## Featherbed Lane - HarBUG Response to Development Proposals

The Featherbed Lane & Steventon Junction developments directly affect existing, major cycle-commuter routes (1) from Abingdon to Harwell Campus, and (2) from Wantage/Grove to Milton Park. Please refer to appended map below.

### Effect of Proposed Developments on Existing Main Cycle-Commuter Routes

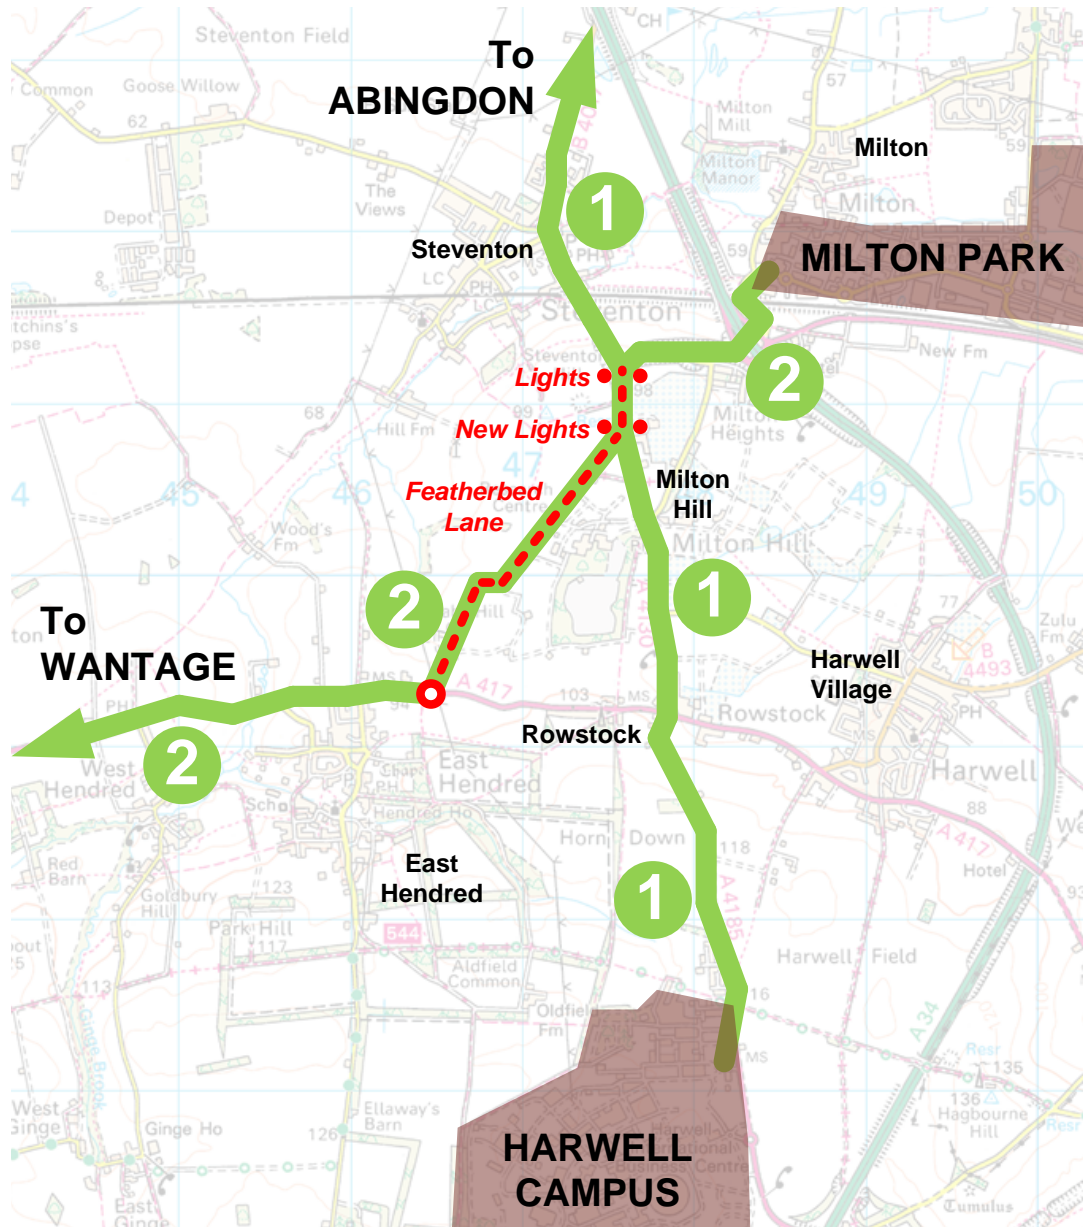
-  Relevant Main Cycle Commuter Routes:
-  1 Abingdon to Harwell Campus (on road)
-  2 Wantage to Milton Park (on road)
-  Proposed New & Improved Roads
